CBER CMC BLA Review Memorandum

BLA STN 125806

**marnetegrane autotemcel
KRESLADI**

Figure 3. RP-L201 DP Long-Term Stability Data (FDA generated)

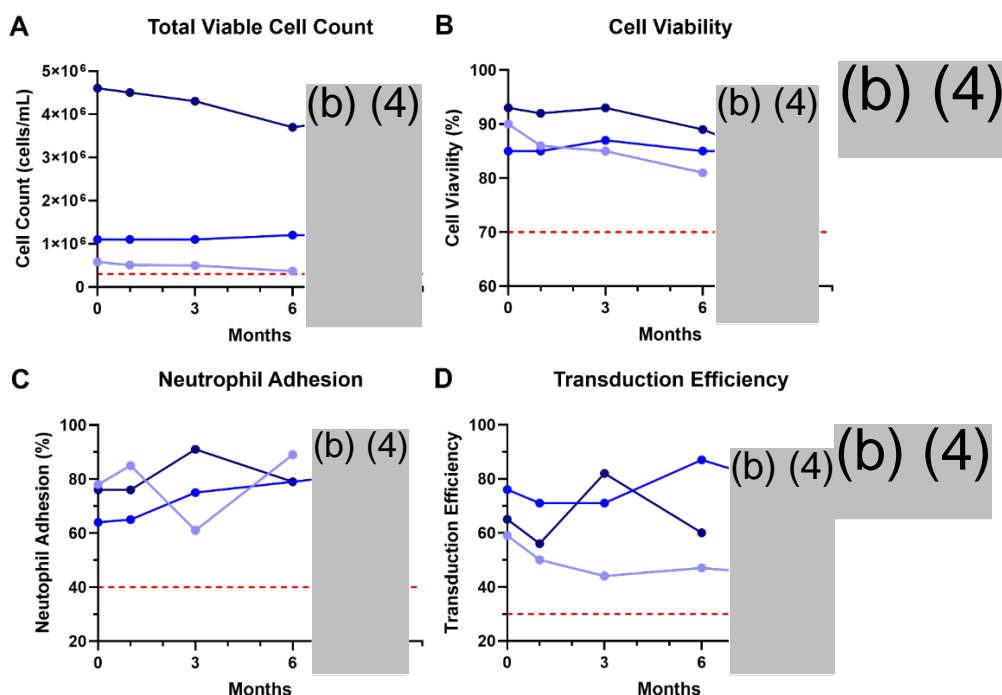
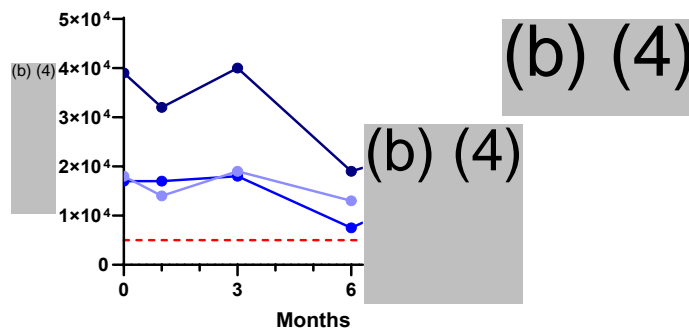
(b) (4) stability lots (b) (4) showed a downward trend in (b) (4) from the 3-month to the 6-month timepoint. In response to IR #9 issued on February 19, 2026, requesting that the Applicant explain this trend and justify the 6-month shelf life, the Applicant submitted additional stability data for DP lot (b) (4) at the (b) (4) month timepoint showing an increase in (b) (4) values between the 6- (b) (4) month timepoints in Amendment 125806/0.103 (24-Feb-2026). The Applicant explained that the decrease in (b) (4) values observed at 6 months is attributed to assay variability rather than an actual downward trend based on: (1) (b) (4) lots demonstrated an increase in (b) (4) values at the (b) (4) month timepoint, and (2) the intermediate precision of the (b) (4) assay is (b) (4) CV.

Reviewer Comment: The Applicant's explanation is acceptable.

Figure 9 – CD11a and CD18 expression on neutrophils in patients treated with RP-L201
(Generated by Reviewer)

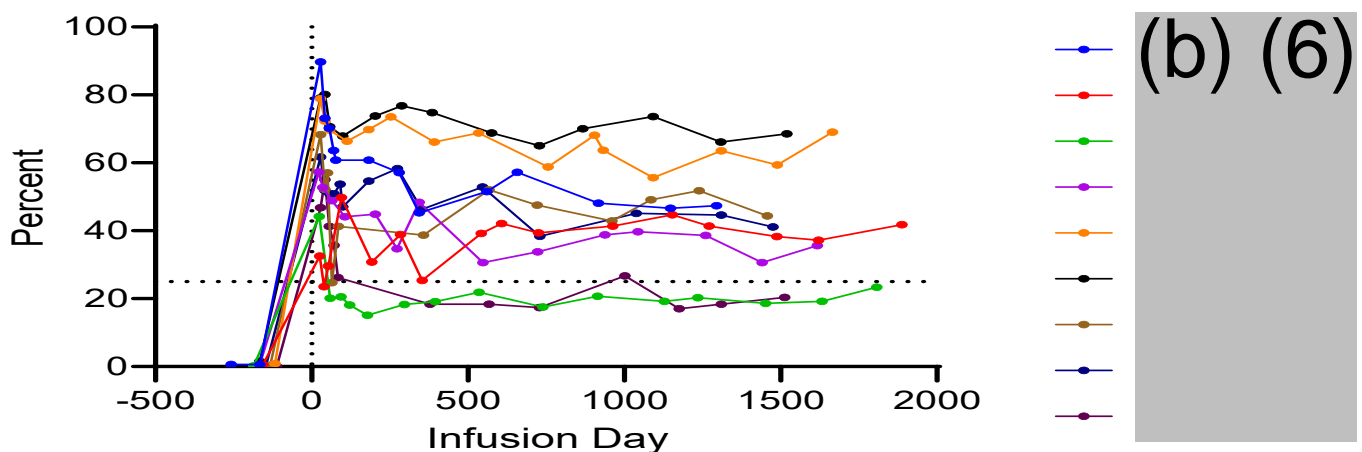
Of note, two patients ((b) (6)) have maintained steady-state CD11a frequencies below the empirically validated range of the assay ((b) (4)), shown as a horizontal dotted line).

Reviewer Comment – Two patients ((b) (6)) have exhibited stable CD11a surface expression at levels below the validated LoQ of the assay. The comparatively low CD11a frequency in these patients aligns with the results of other clinical assays (specifically VCN; see Figure), suggesting that these observations do not stem from poor sample quality or assay limitations.

Figure 10 – Correlation between PB neutrophil CD11a expression and PB neutrophil VCN (generated by reviewer)

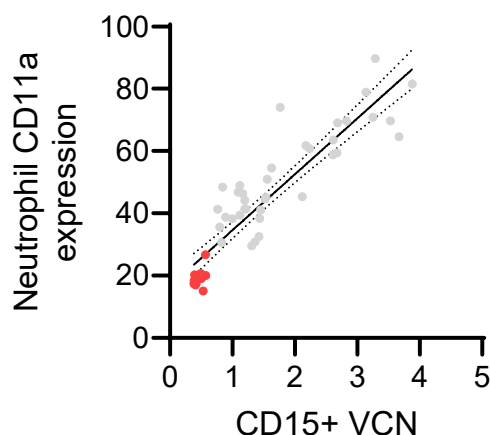
Reviewer Comment – The frequency of CD11a+ neutrophils in peripheral blood is significantly correlated with the vector copy number of peripheral blood neutrophils over time ((b) (4)). Data from N=50 (same patients over time) assessments of PB VCN and CD11a frequencies are plotted, and an unconstrained linear regression was fitted to the data, along with ((b) (4)) confidence bands.
